Brunswick County Courthouse Addition & Renovations

Addendum 3

January 13, 2020

SAWYER SHERWOOD & ASSOCIATE ARCHITECTURE

1 / A6.2 Lobby Glass Barrier
Scale: 1/2" = 1'-0"

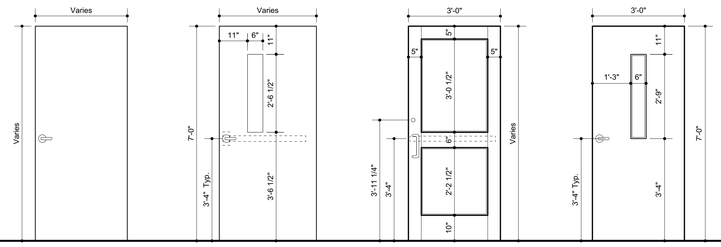
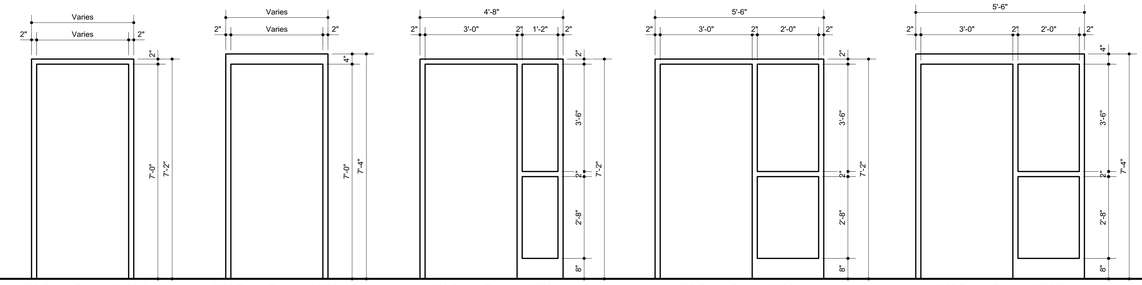
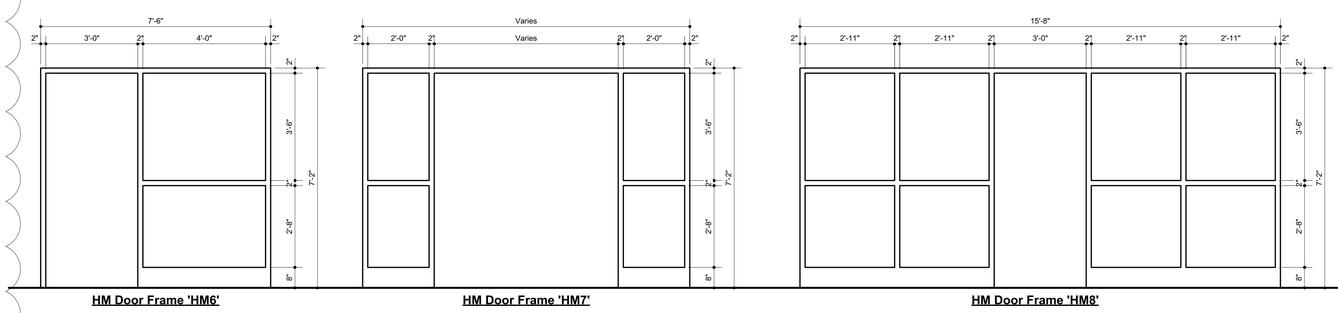
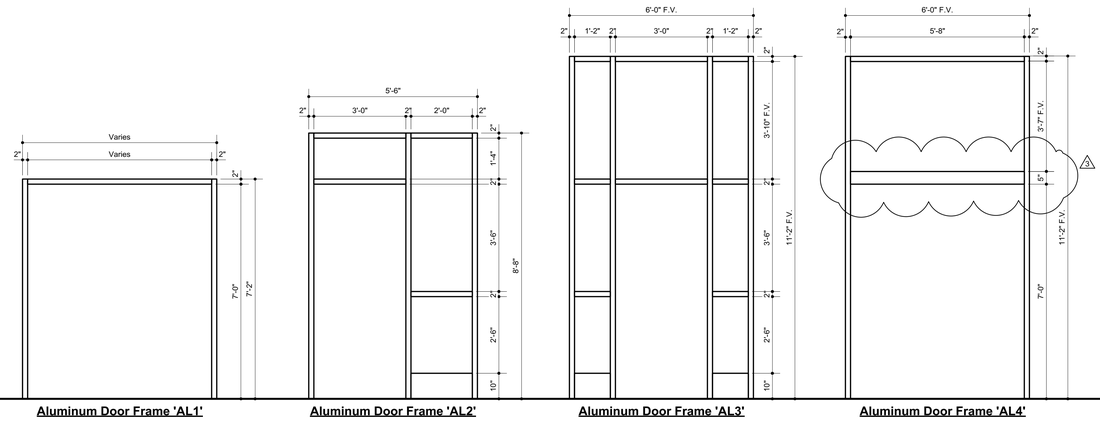
26. Sheet A6.2 is reissued and enclosed with the following clarifications and revisions:
    a. Elevations have been added to define butt glazed partitions in Lobby 1000.
    b. Aluminum Door Frame AL-4: transom member changed to coordinate with door hardware.

1 A7.4 Courtroom #2 , #3 & #7 Judge Casework Section
Scale: 1" = 1'-0"

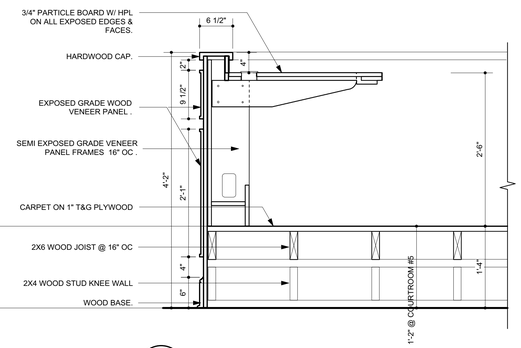
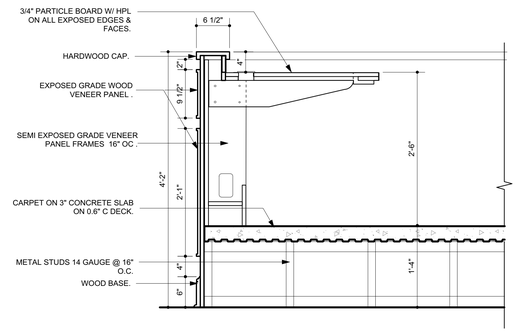
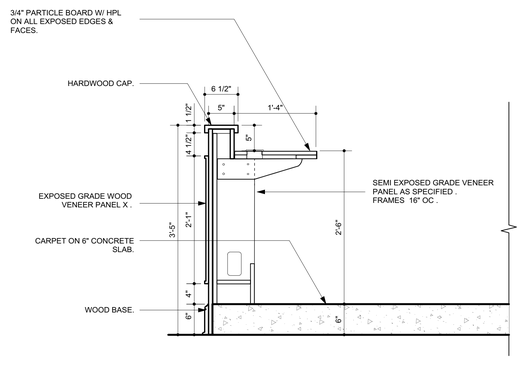
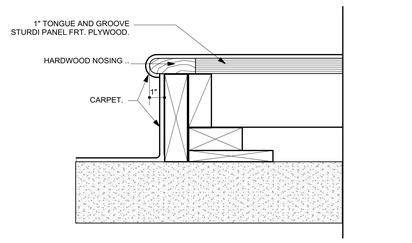
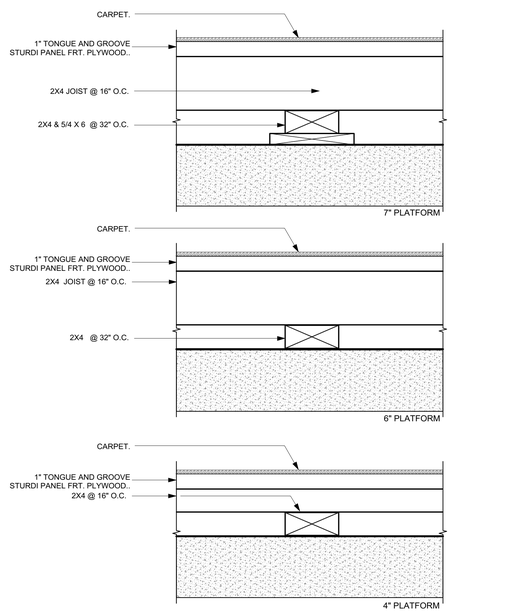
27. Sheet A7.4 is reissued and enclosed with the following clarifications and revisions: courtroom bench details and sections have been revised.
    a. Courtroom 2, 3, & 7: The existing bench will be modified to lower the judge's area. The existing floor platform construction is metal framing.
    b. Courtroom 5 & 6: The entire bench and jury box will be new. Construction is in FRT wood. Contractor is permitted to change this to metal framing. The metal framing option will require a framing plan and detail to be submitted for review and approval.
    c. Courtroom 4 is new construction. Bench and jury box platform will be metal frame and concrete construction as shown in the structural plan set.

11 A7.5 Closure for Existing Coiling Doors 3
Scale: 3" = 1'-0"
OCCURS AT FIRST AND SECOND FLOOR ELEVATOR LOBBY

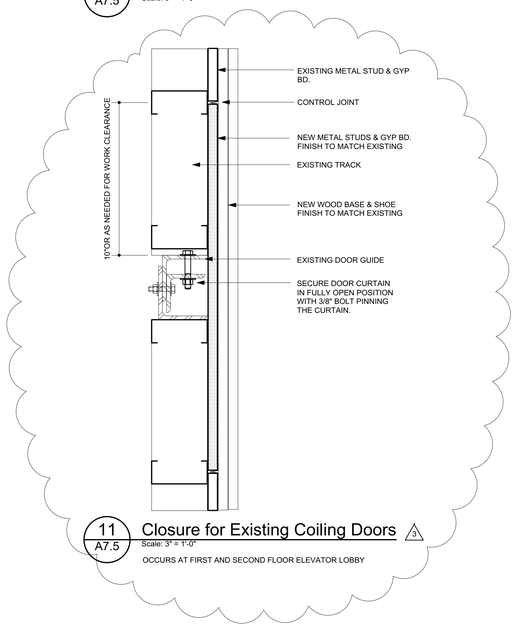
28. Sheet A7.5 is reissued and enclosed with the following clarifications and revisions:
    a. Elevation 10 has been added.
    b. Detail 11 has been added to address abandoning in place the first floor and second floor elevator lobby overhead coiling fire doors.

1 A7.8 Second Floor Plan
Scale: 1/8" = 1'-0"

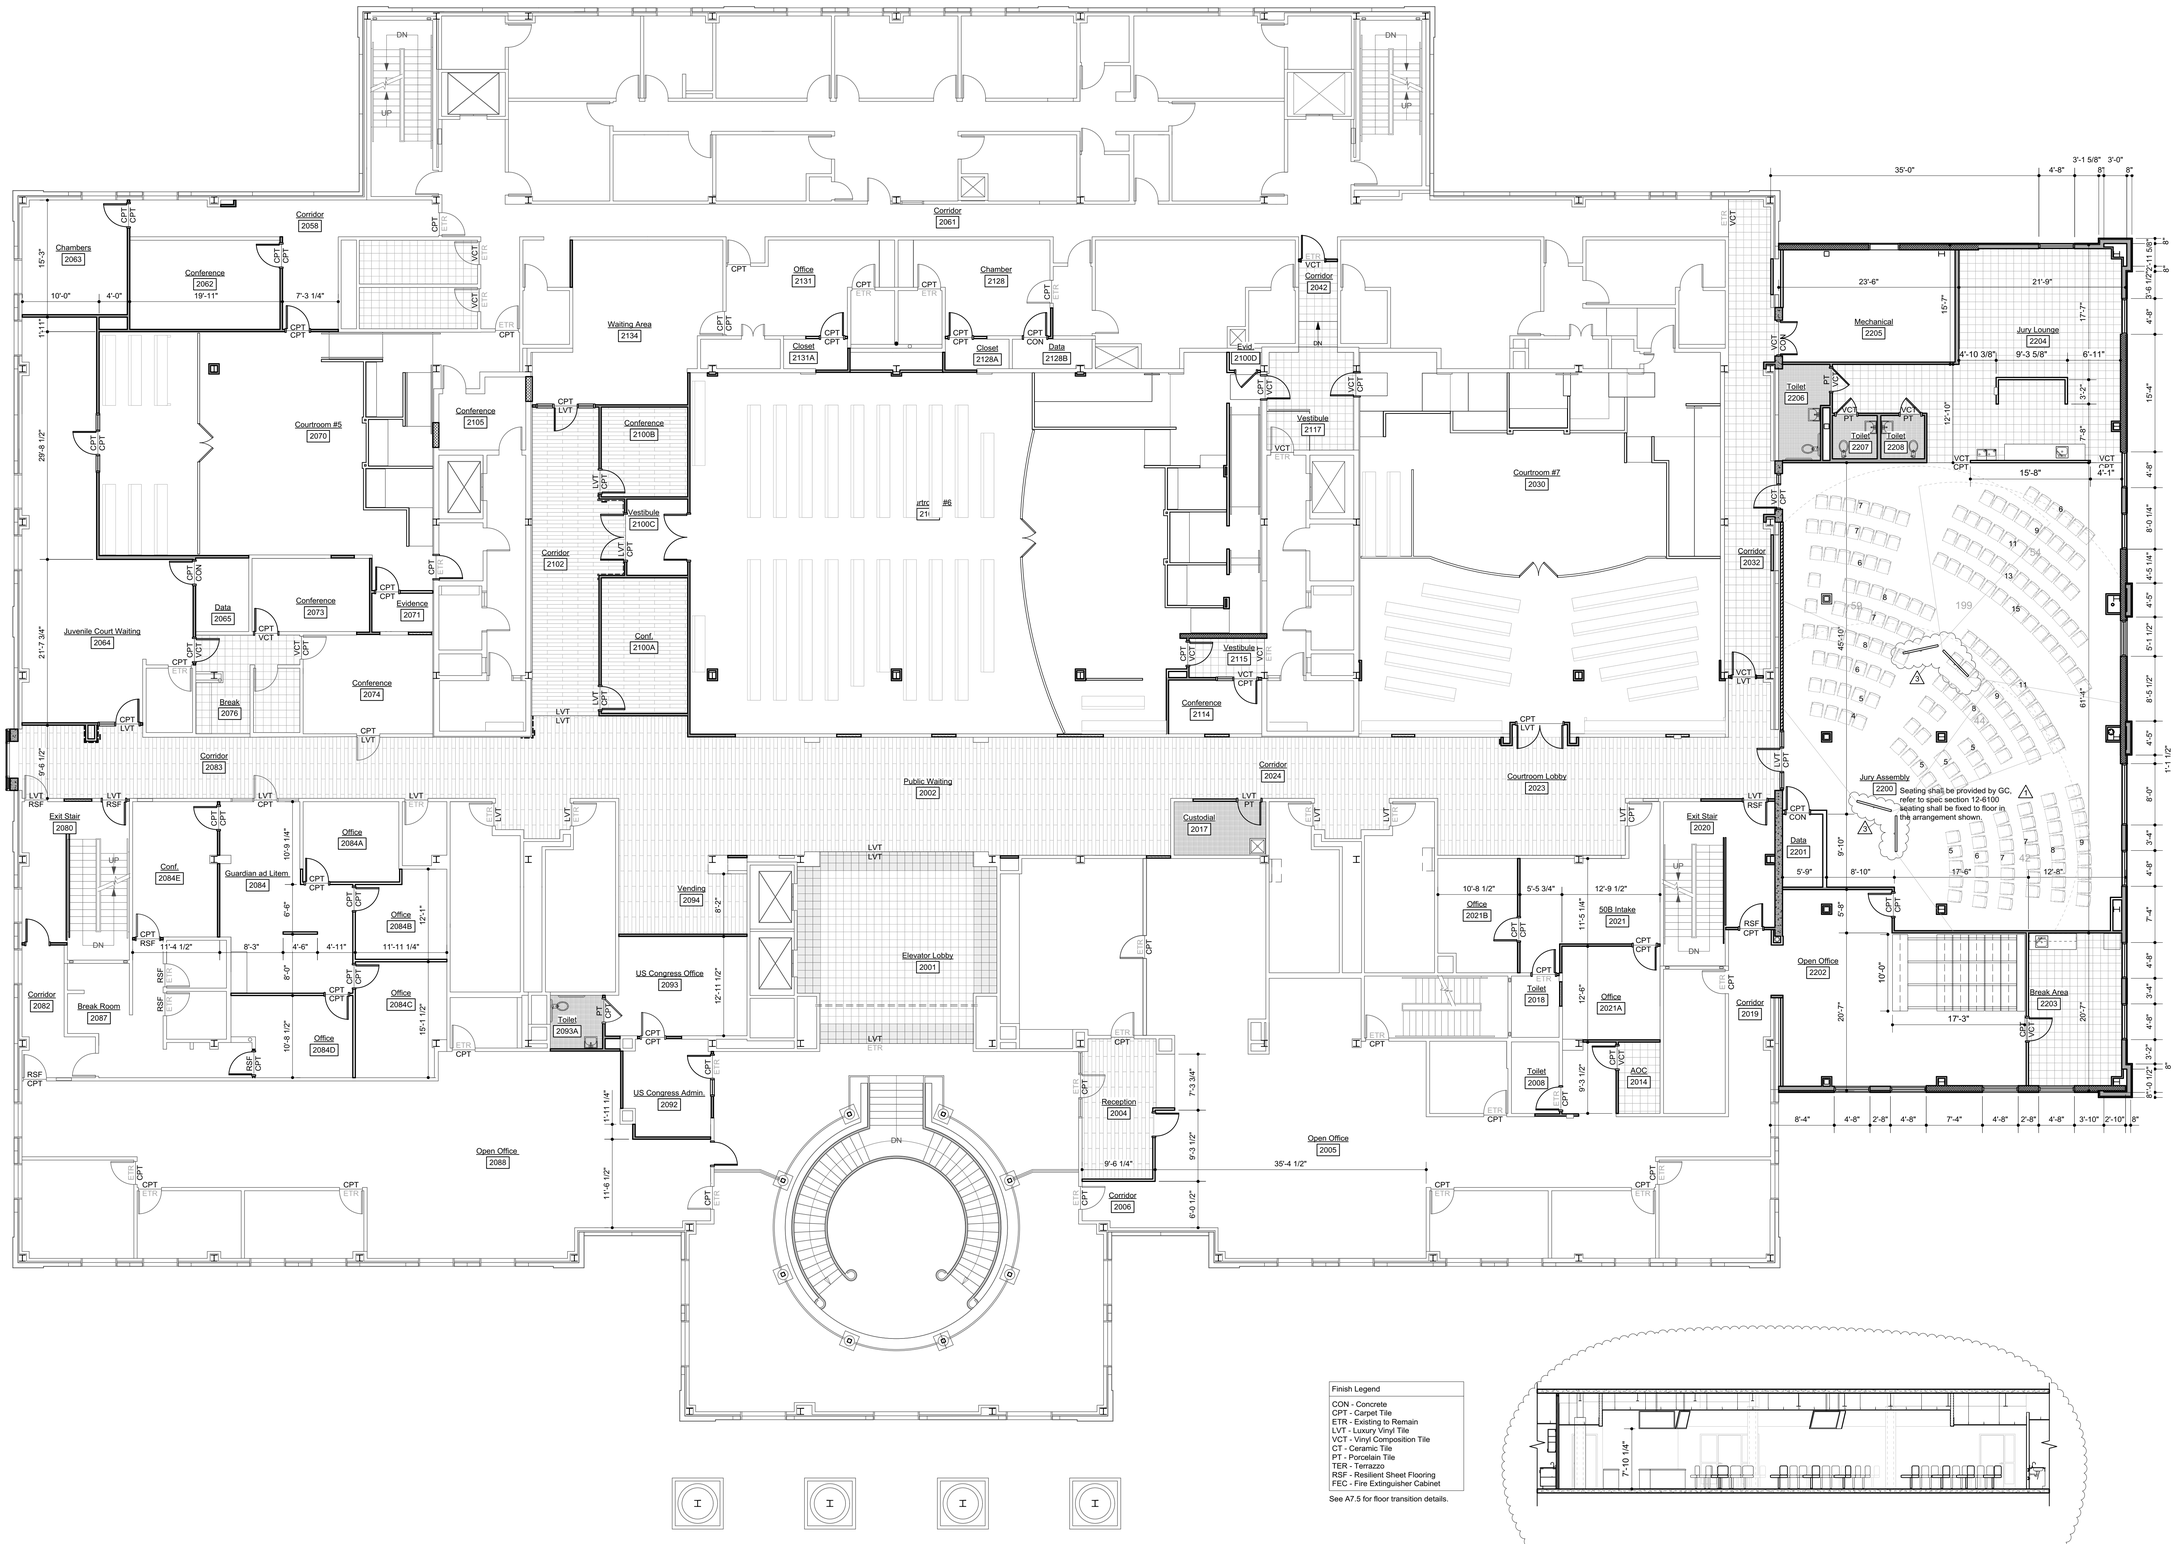
29. Sheet A7.8 is reissued and enclosed with the following clarification/revision: Four TV mounts are to be installed in room 2200.

M8.1

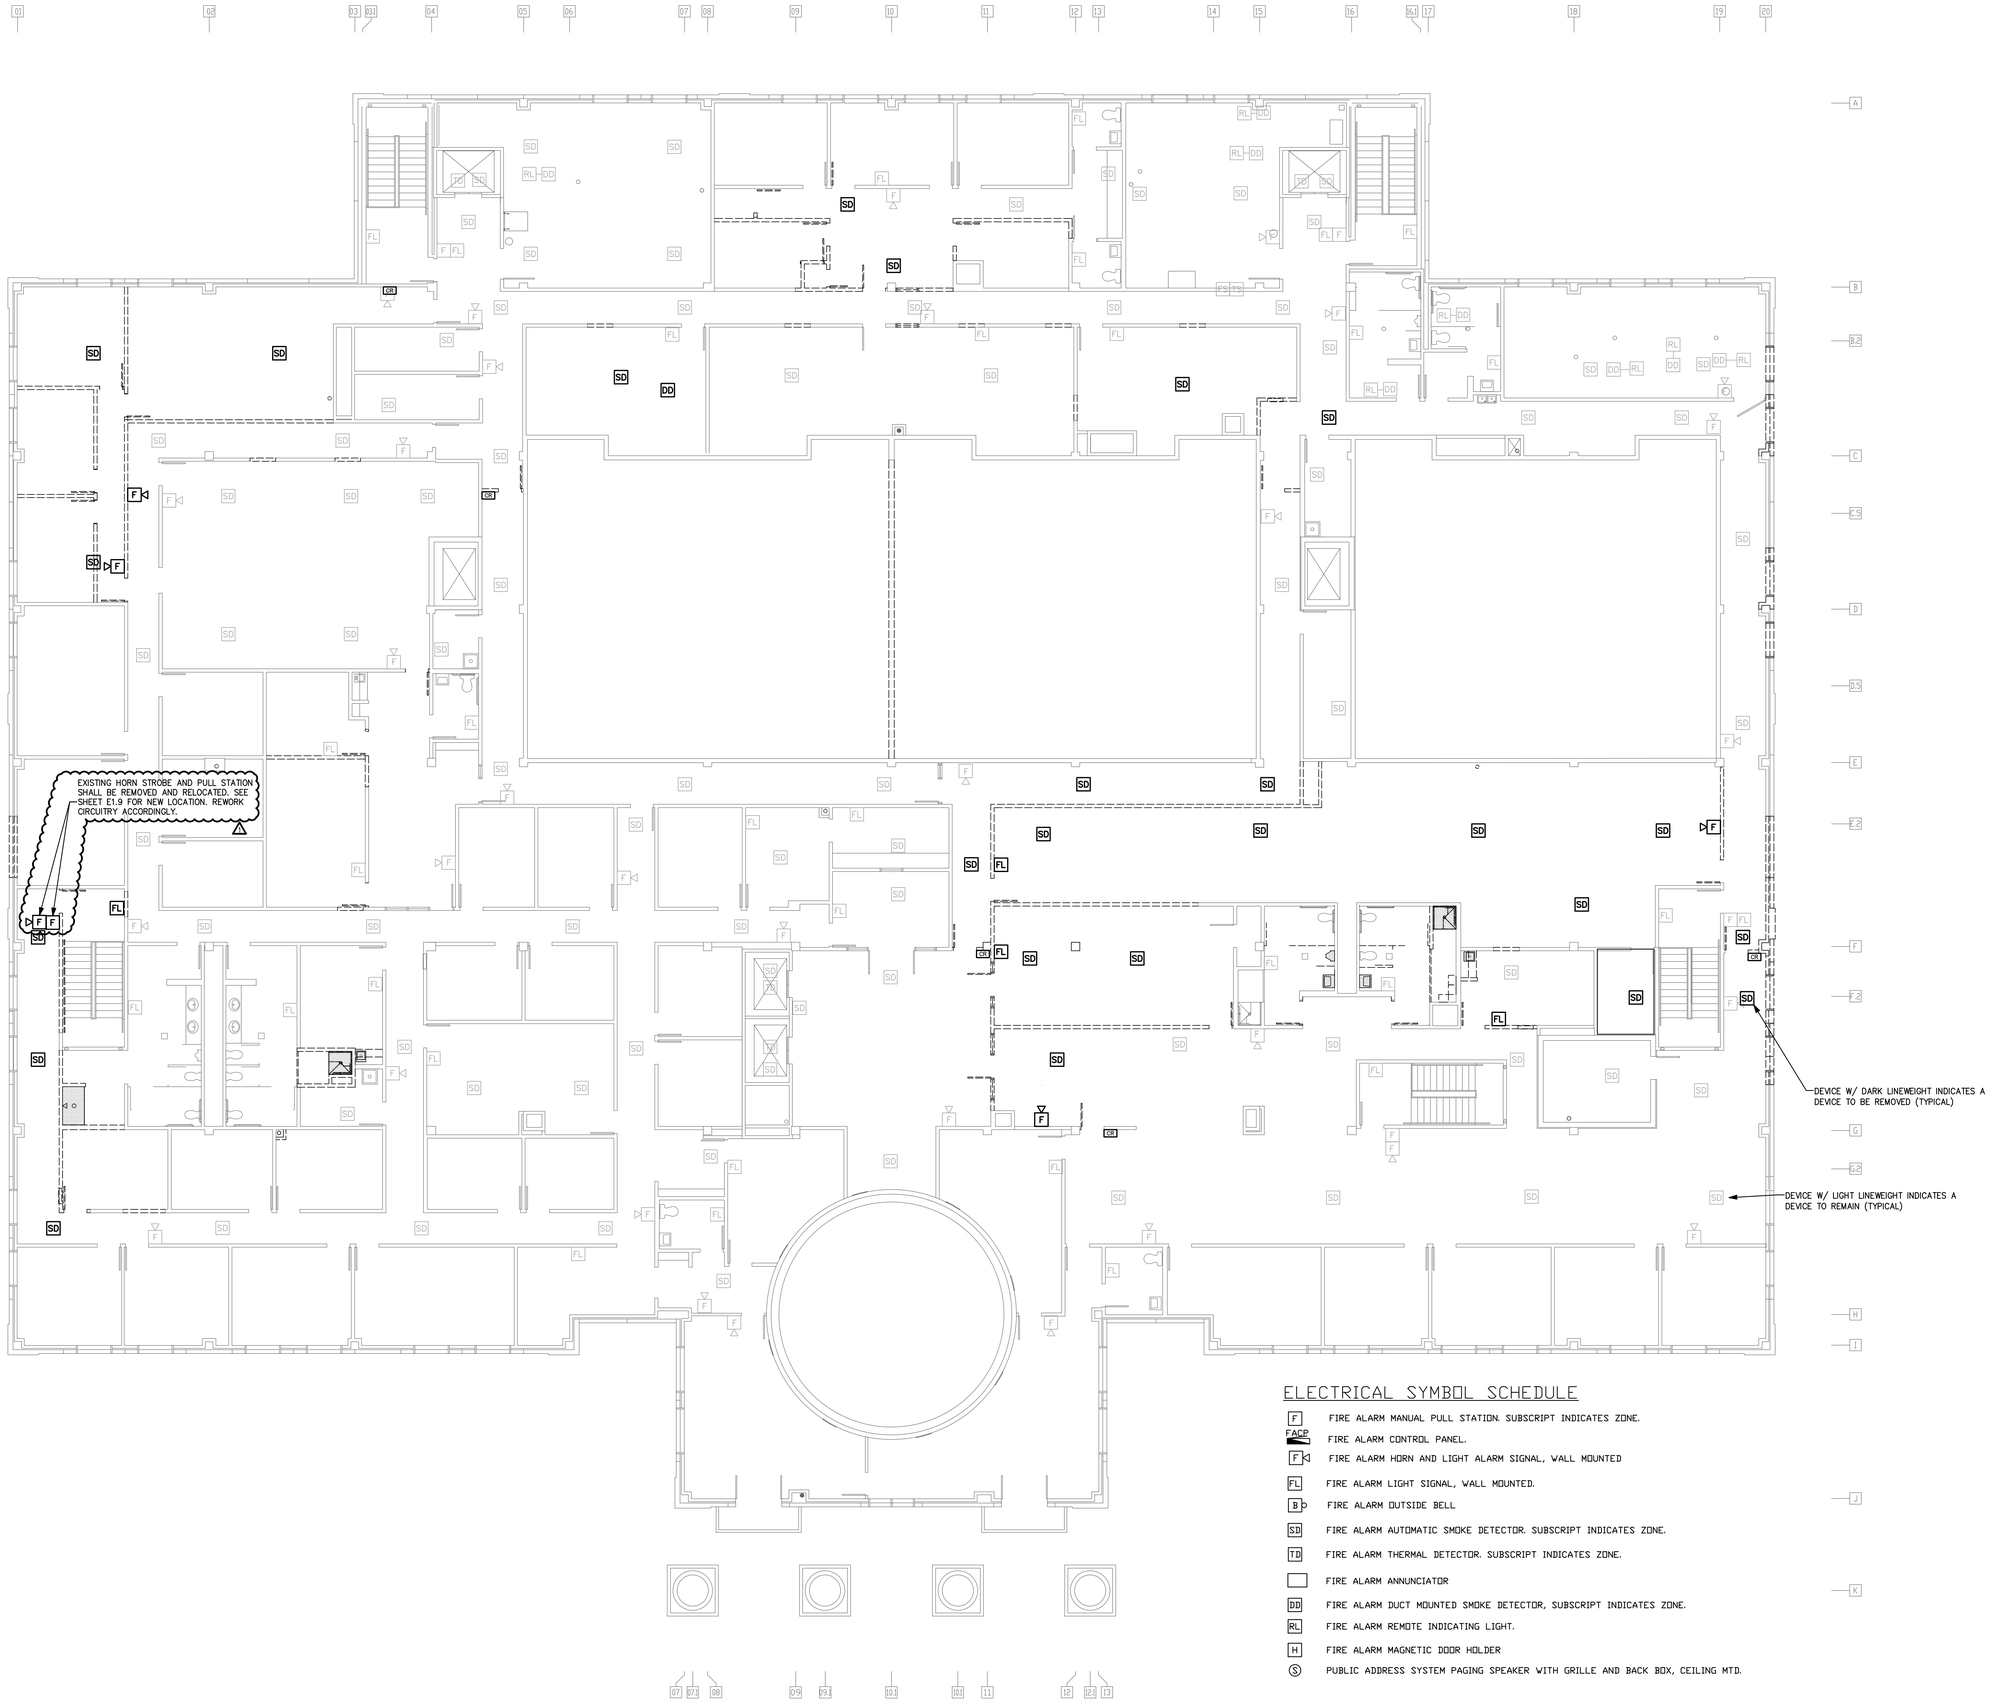
32. Sheets M6.0 & M8.1 are reissued and enclosed with the following clarifications and revisions: Alternate No. M-1 shall be to replace the DDC controls on the existing Series Fan Power Terminal Units, existing Parallel Fan Power Terminal Units, and existing VAV Room Terminal Boxes as indicated on revised drawings. New DDC BAS controls for these existing units shall be turnkey complete for each unit including:

f. Space temperature sensors shall be wireless wi-fi type as specified to connect to existing DDC wireless mesh system. Install sensors in same location as existing space sensors. Patch and/or paint walls as necessary to cover existing sensor installation or provide stainless steel cover plates.

g. Replace or provide new discharge air temp sensor from each terminal unit or box.
    h. Remove existing unused control wiring, conduits may remain.
